MACHEnergy

MOUNT PLEASANT OPERATION
MINE OPTIMISATION
MODIFICATION

**Response
to Submissions**

Figure 1

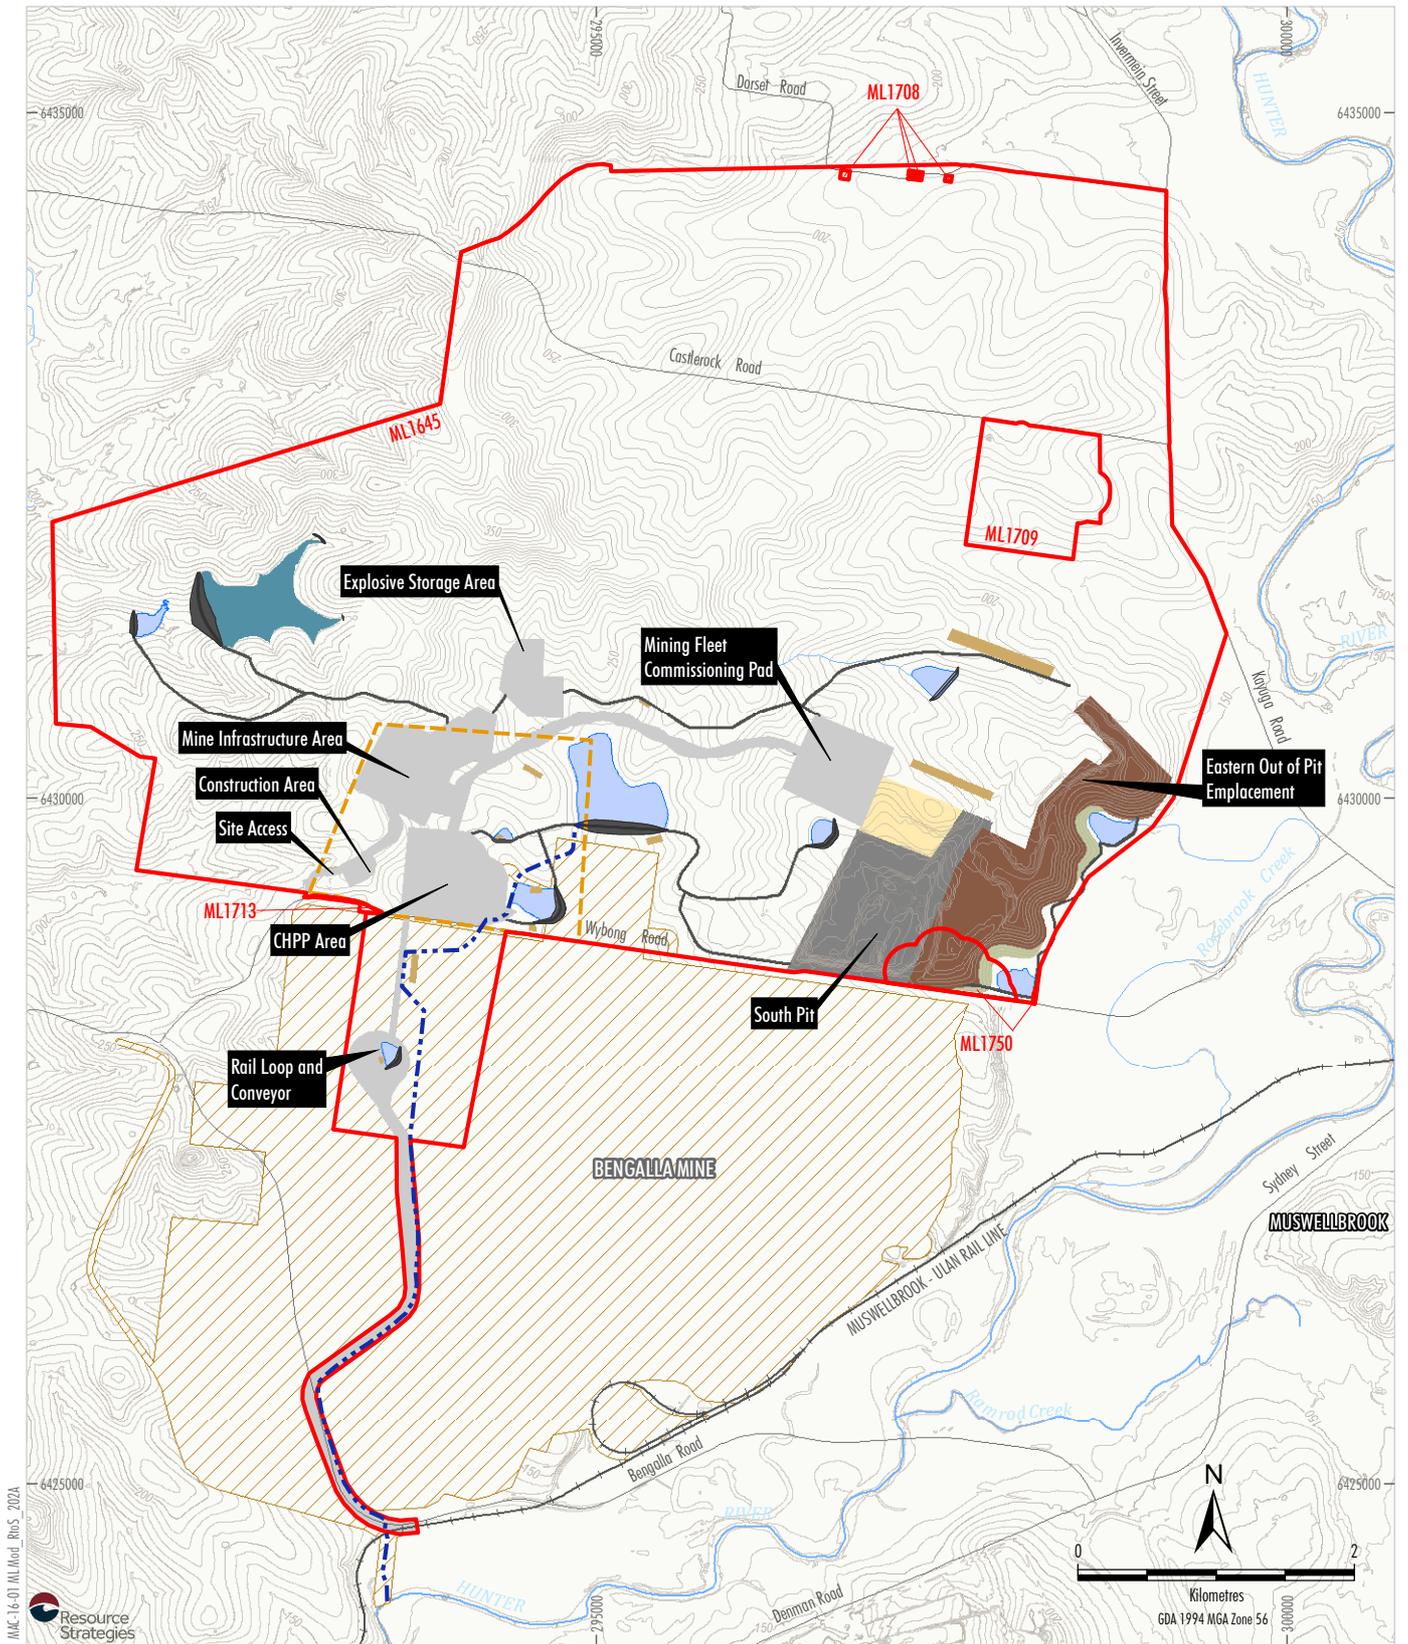
An updated version of the 2018 Provisional General Arrangement (Figure 10 of the Environmental Assessment) is provided as Figure 1. This figure corrects a minor inconsistency between the Environmental Assessment and the supporting appendices to show the initial rehabilitation on the eastern face of the Out of Pit Emplacement in 2018. This correction makes the 2018 Provisional General Arrangement consistent with the Air Quality Assessment and Site Water Balance Review assessments presented in the Environmental Assessment that included this initial rehabilitation.

Figure 1: Indicative mine plan for Scenario 1 with modelled source locations

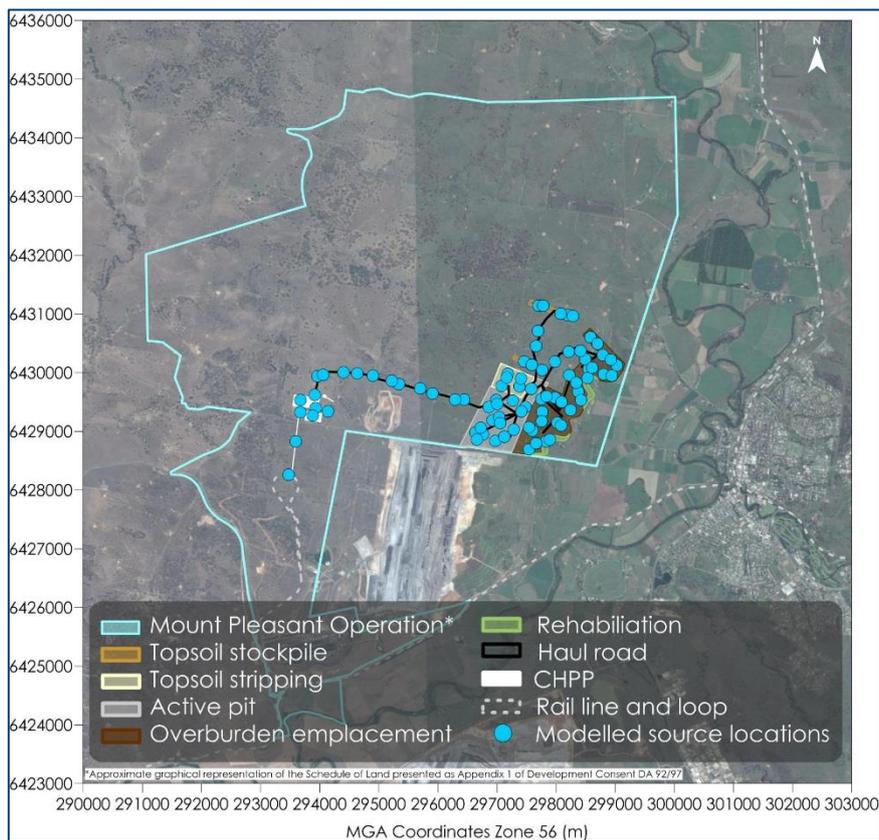
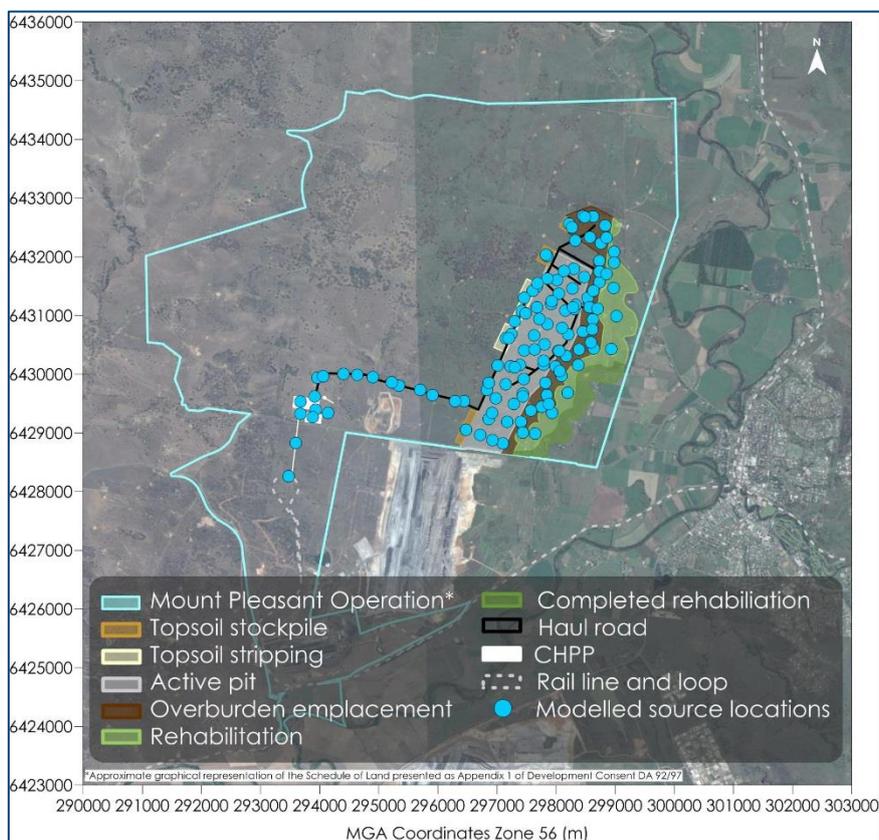
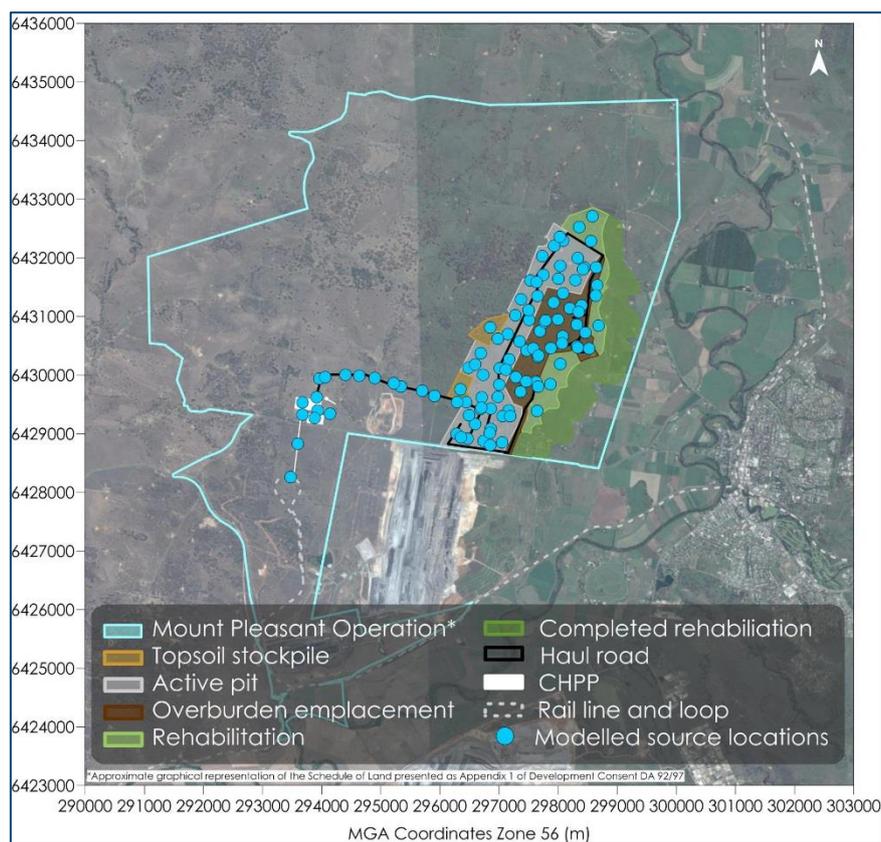
<p><i>When comparing the indicative mine plan in the EA with AQA Scenario 1 (2018), the AQA shows an area of rehabilitated land that is not shown in the EA.</i></p>	<p>Figure 5-2 of the AQA and Figure 1 present the proposed area for rehabilitation for Scenario 1.</p>
<p><i>With the exception of the difference in the boundary noted above, the indicative mine plans for 2021 and 2025 appear to be similar in both the EA and AQA. However, without detailed information on the location of source, it is not possible to determine if activities have been accurately represented in the AQA.</i></p>	<p>Refer to Figure 2 to Figure 3.</p>
